THE MARYLAND-NATIONAL CAPITAL PARK AND PLANNING COMMISSION

MEMORANDUM

PROJECT: Fairland Road Improvements
From Columbia Pike (US 29) to Prince George's County
CIP Project No. 509337

REVIEW TYPE: Mandatory Referral No. MR# 02813-DPW&T-1

TREE LOCATIONS
CLOSED SECTION ROADS

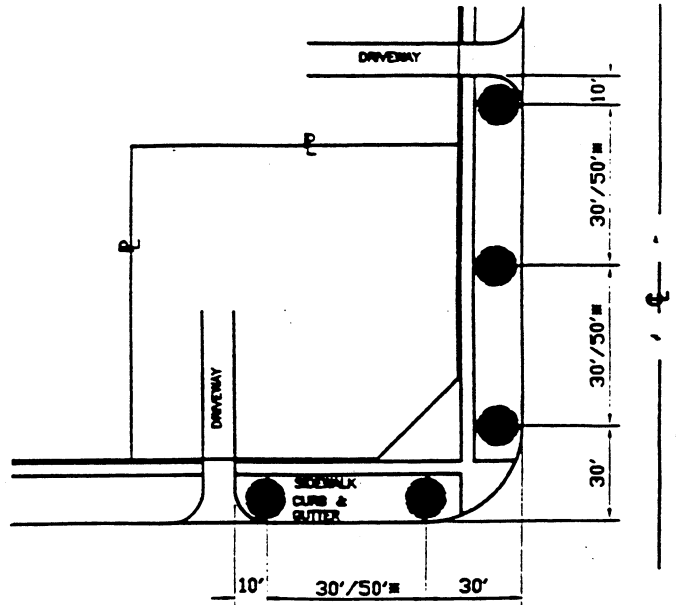
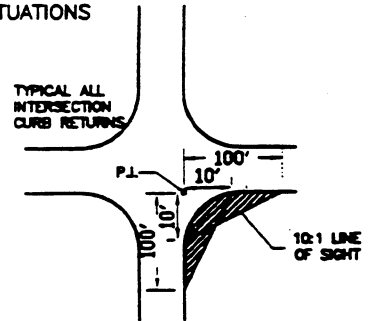
The issue of where street trees should be located was discussed during the facility planning of this project but was not resolved. The typical location per the County's road standards on closed section roads is between the curb and sidewalk (see Attachment 3).

DPWT staff has expressed a concern generally that the typical location of street trees does not provide a sufficient degree of safety for errant drivers who leave the roadway on arterials and major highways, and that a greater offset of trees from the roadway needs to be provided.

5. The proposed landscape panel between the curb and sidewalk should be seven-foot wide. Landscape panels should be planted with street trees in areas without closely-spaced driveways.

ATTACHMENT 4

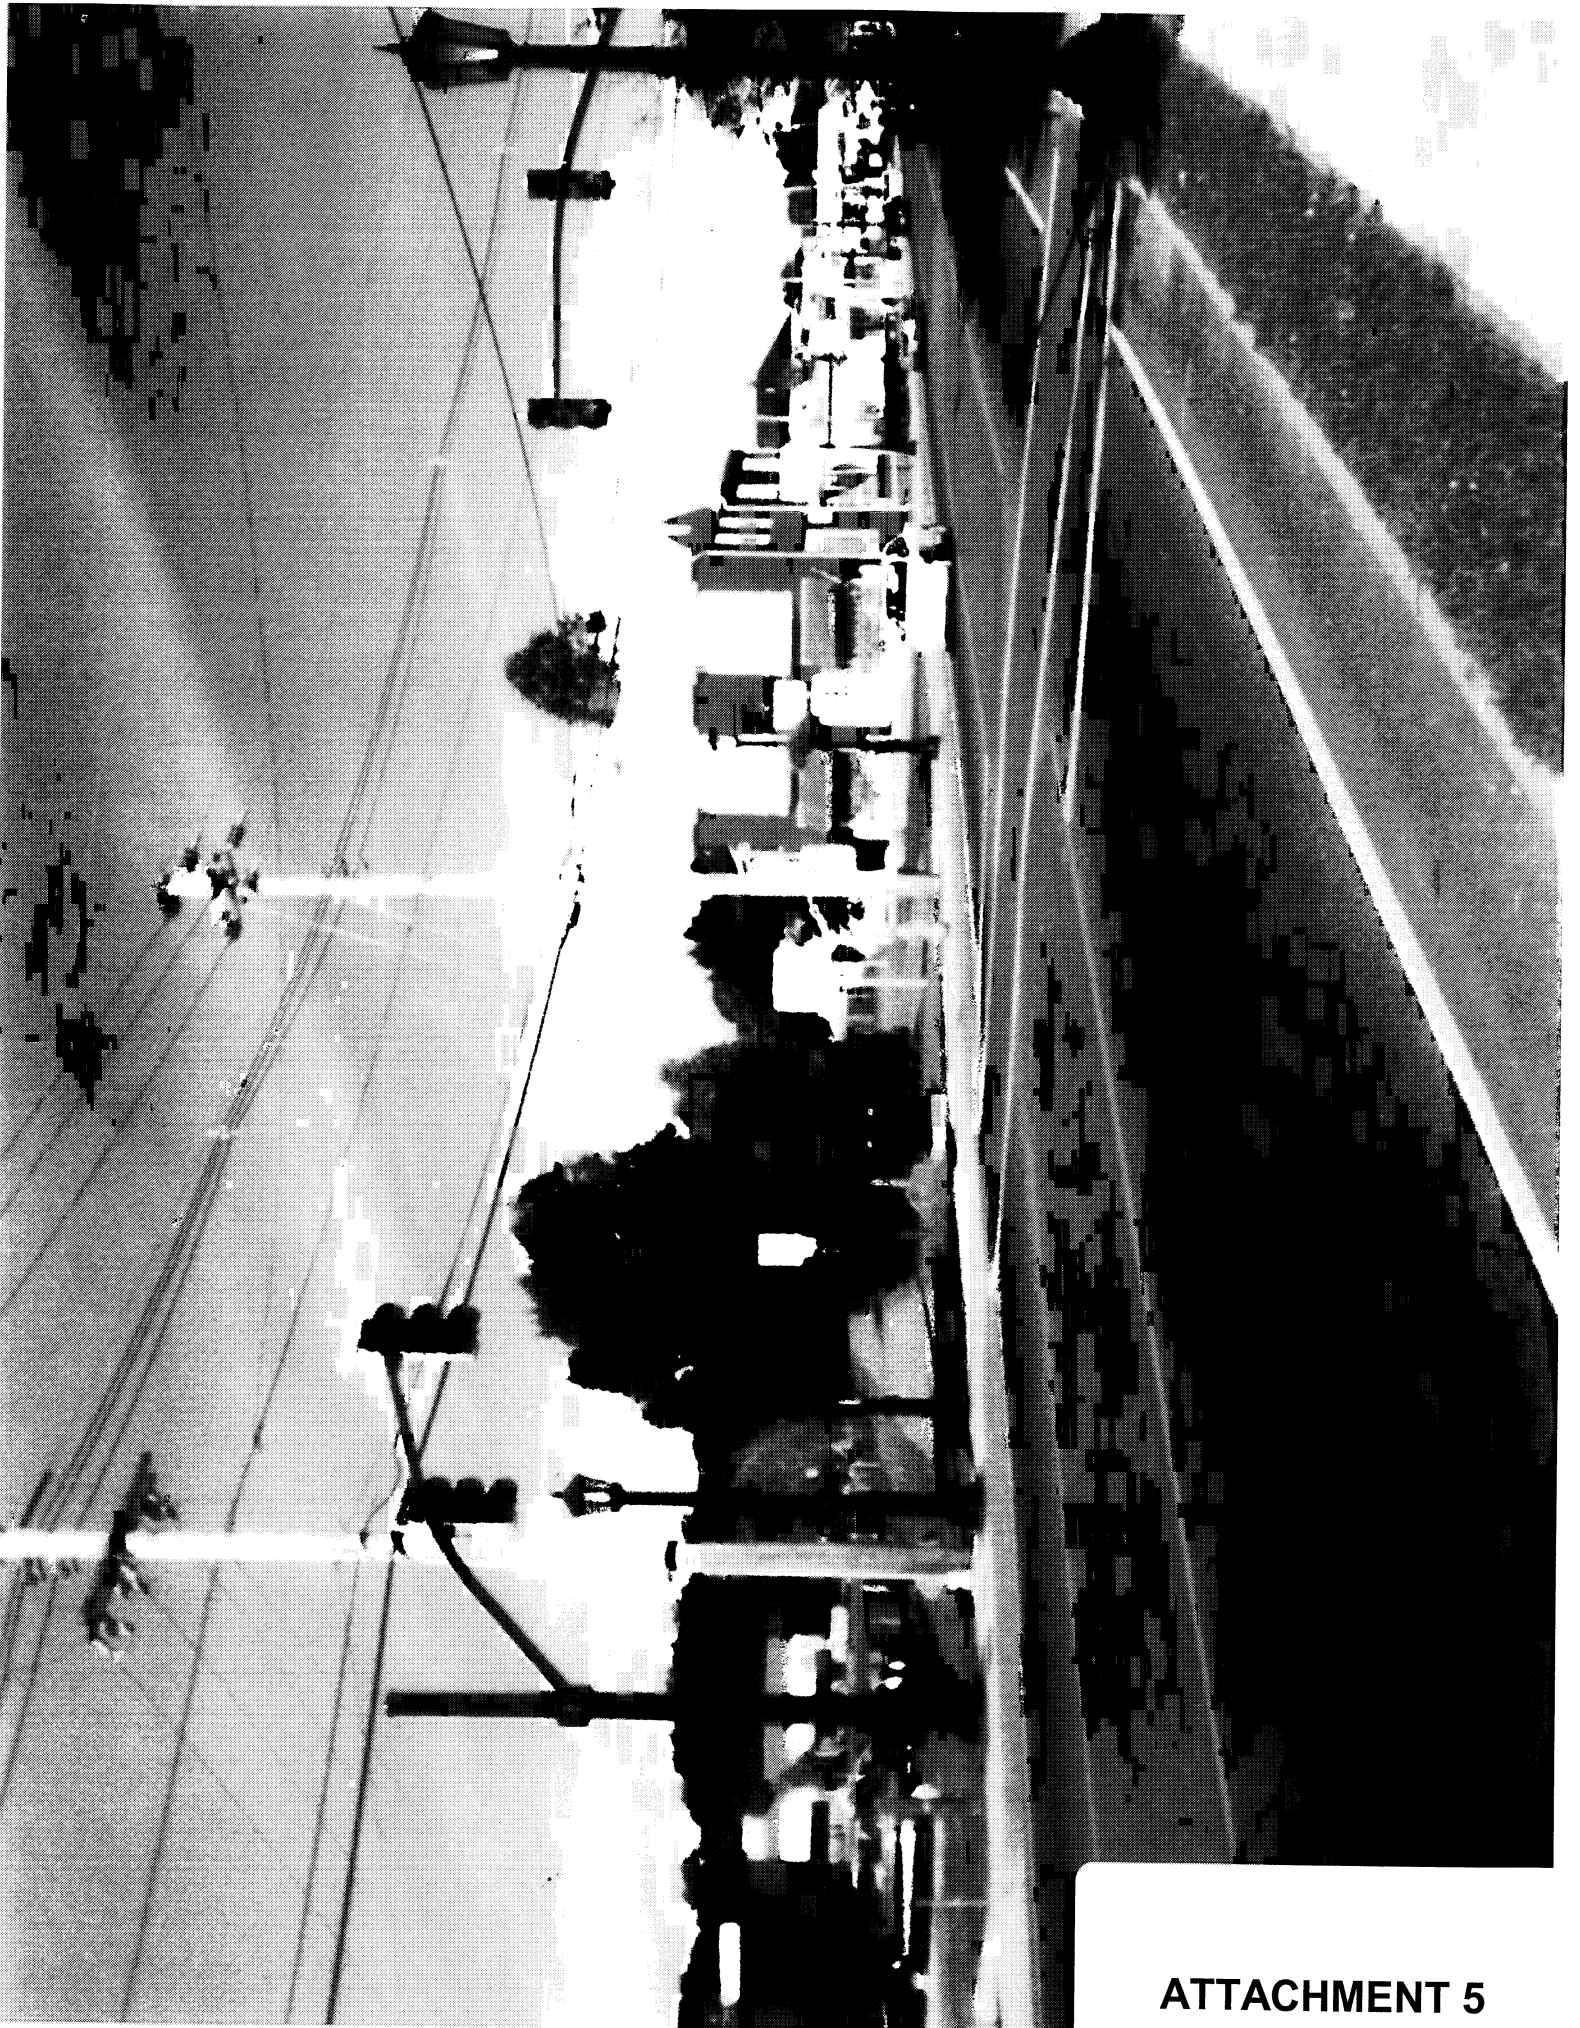
There are two areas within the project limits where there are closely-spaced driveways: on the south side of Fairland Road between Musgrove Road and Marlow

Place, and along both sides of Fairland Road between Galway Drive and Big Horn Drive. These areas are shown as Attachment 4. Staff believes that the driveways are a reasonable concern, but one that in this case is alleviated by the proposed four-foot wide on-road bike lanes. Drivers should have an unobstructed view of oncoming traffic without pulling out into the travel lane. Staff agreed not to contest moving the trees to the back of the sidewalk in these areas, but DPWT has insisted that all trees be moved to the back of the sidewalk.

6. Modify the typical fifty foot-spacing of street trees where necessary to accommodate the irregular spacing of driveways and retention of existing trees.

Exhibit 1-10. Typical urban single-lane roundabout.

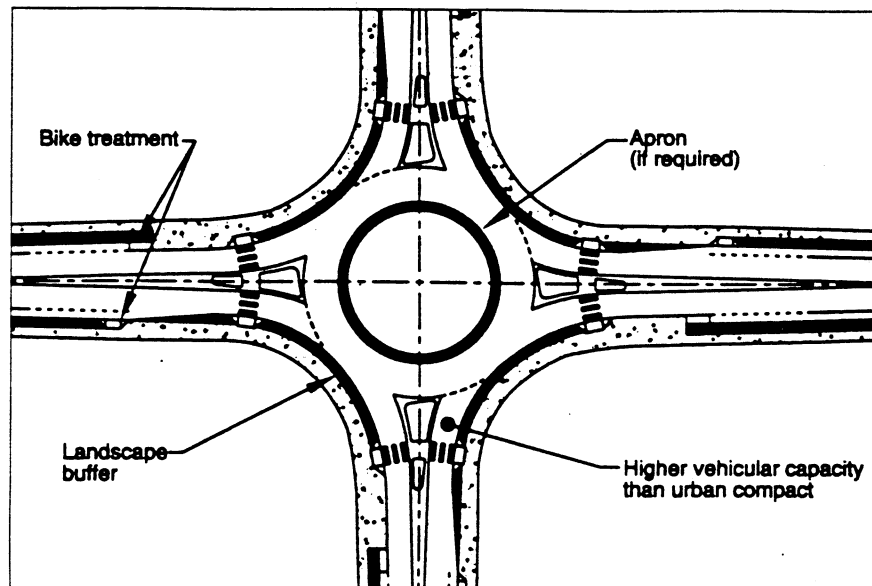
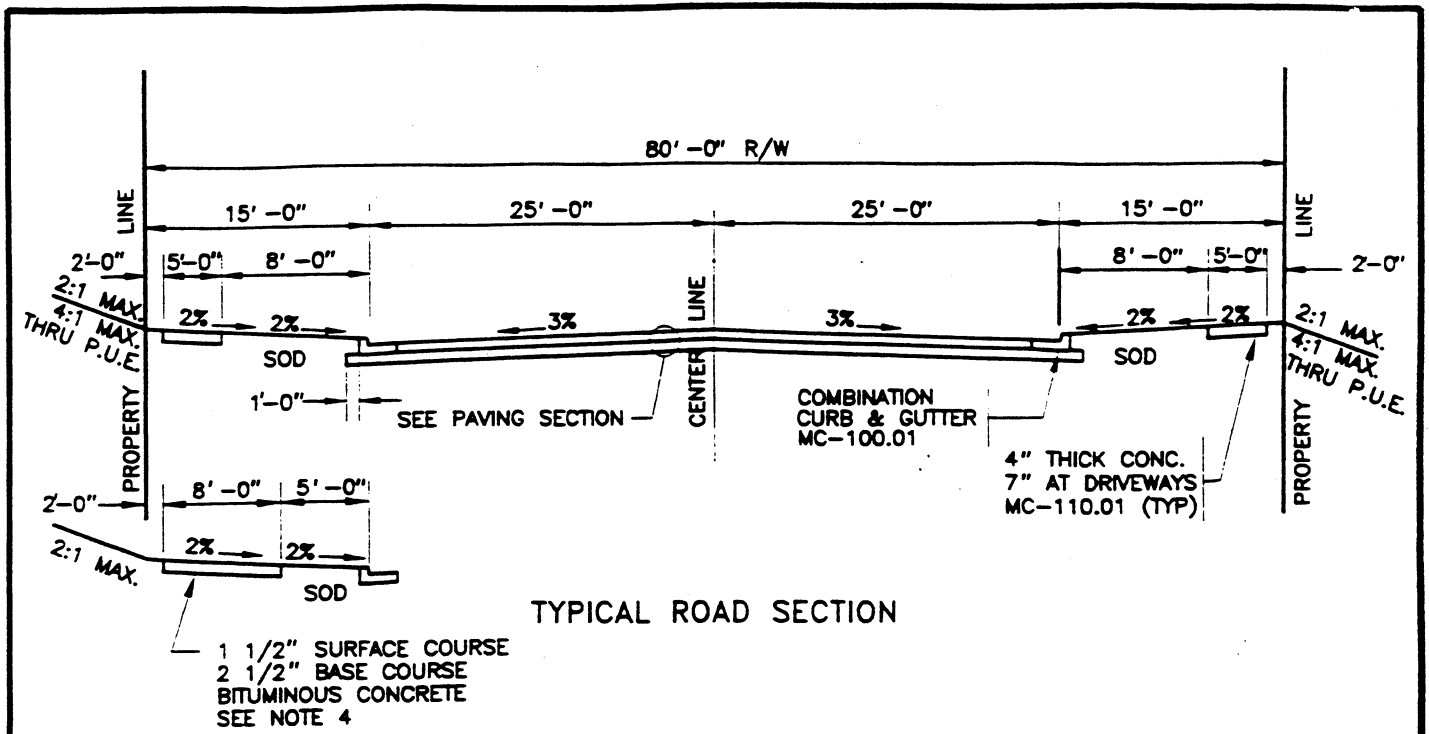
Attachment 8 is an excerpt from this guide illustrating the urban single-lane roundabout. The left side of the diagram has an arrow to a second set of ramps on this leg of the intersection with the designation "bike treatment". These ramps would allow bicyclists the option of riding on the sidewalk through the roundabouts area. Beyond the ramps the roadway is narrowed to force bicyclists who wish to remain on-road through the roundabout to share the travel lane with other vehicles, reducing the potential for angle collisions around the central island. ***Staff recommends that the design for the proposed roundabouts be modified to reflect these bicycle features.***

1. Median pedestrian refuges should be constructed at T intersections and on both legs of Fairland Road at the park entrance. Consider using alternative paving materials for the crosswalks at the park entrance.
2. Construct dual handicap ramps where feasible at all intersections to provide the best ADA accommodation and shortest pedestrian crossings of Fairland Road. All T intersections should have at least one ADA-accessible crosswalk across Fairland Road, whether marked or unmarked.
3. Sidewalks should be constructed within the limits of the proposed curbing on all side streets.
4. Modify the design of the proposed roundabouts to reflect the bicycle treatment recommendations of the Federal Highway Administration (FHWA) in their publication "Roundabouts: An Informational Guide".

Exhibit 7-24. Landscaping of the central island.

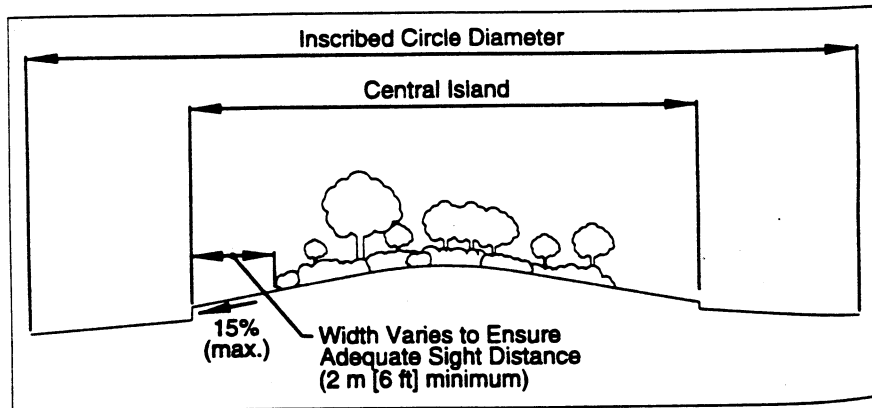
Staff recommends that ornamental trees and other landscaping materials be planted in the proposed roundabouts. As noted in Attachment 10, from the FHWA guide referenced above, landscaping in the central island helps to enhance the safety of the intersection by making it a focal point and lowering speeds. Well-designed landscaping would also help to mitigate the intrusion posed by the size of the roundabouts, which would bring the roadway closer to homes and apartments than the existing intersection. Good landscaping would help to make the central island a visual asset.

8. Plant ornamental trees and other landscaping in the proposed roundabouts. Provide an enhanced landscape treatment at other intersections to provide a transition between segments of roadway with different street tree locations.
